**STATE PROJECT NO 412-04-0013**  
**FEDERAL AID PROJECT NO. 5508(501)**  
**LA 316 SHOULDER WIDENING AND DRAINAGE**  
**ROUTE LA 316**  
**TERREBONNE PARISH**

**SUBJECT: ADDENDUM NO. 1 (CONSTRUCTION PROPOSAL REVISION)**

Page: 3a

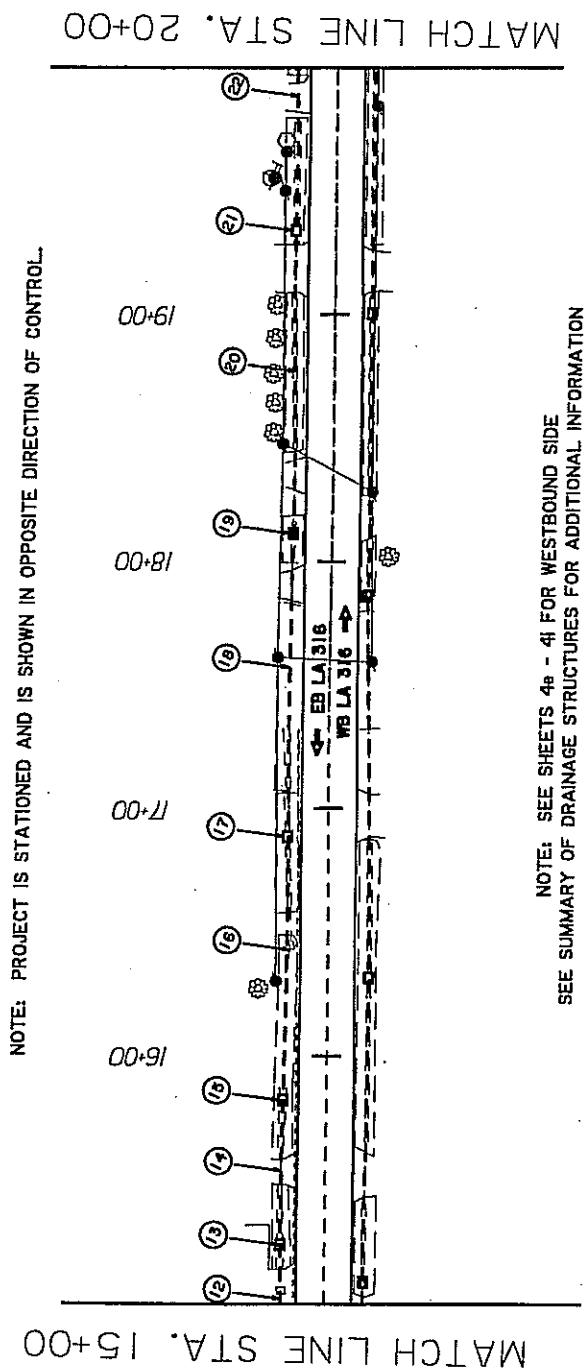
1. Revised the Notice to Contractors. (1 page)
2. The **Supplemental Specifications for the 2006 Standard Specifications (08/08)** has been deleted.
3. The **Supplemental Specifications for the 2006 Standard Specifications (05/09)** has been added. (35 pages)
4. Added plan sheets 3a and 4a. (2 pages)
